Response to Submissions Report

State Significant Development – SSD 17_8926

International Maarif Schools of Australia – Gallipoli Campus

2 Percy Street, Auburn

Figure 2 Gelibolu Parade - Street Section

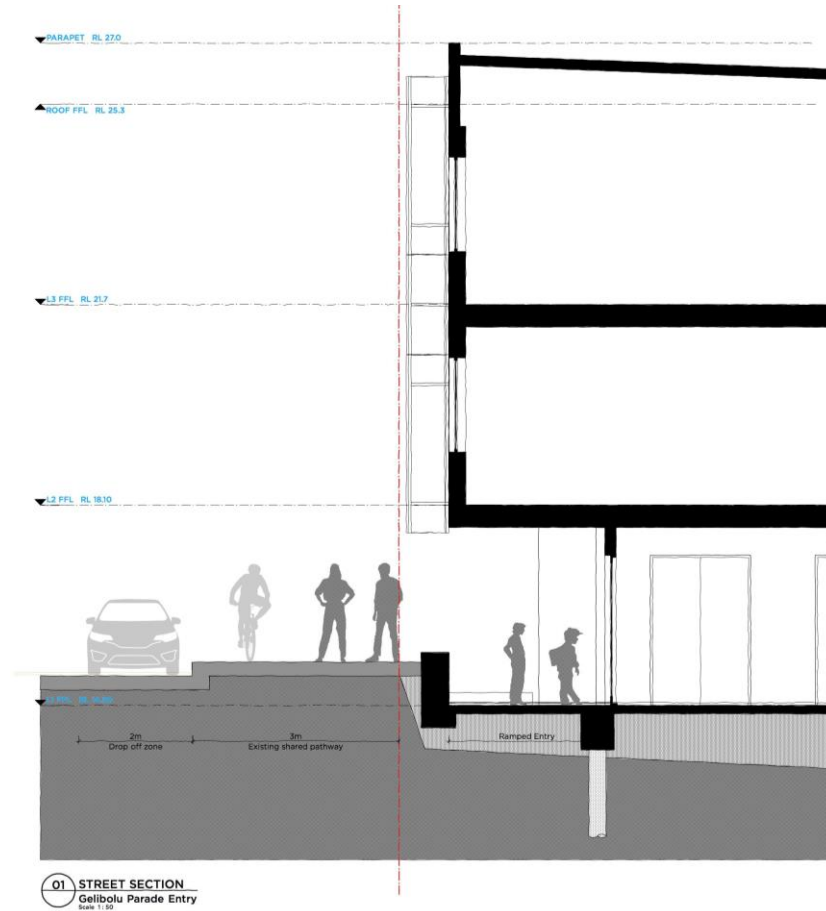
Issue	Response	Reference
The submission explains how the proposal responds to contextual considerations including connections with immediate surroundings, traffic mitigation measures, such as the pedestrian crossing in Percy Street and the drop-off/pick-up zones and extended shared paths. However, a series of street sections at a closer scale (i.e. 1:50 scale) are necessary to understand the appropriate widths for all users including vehicles, pedestrians, bicycles, street trees and soft planting.	Street sections at 1:50 are provided at Figure 2 and Figure 3 below.	n/a
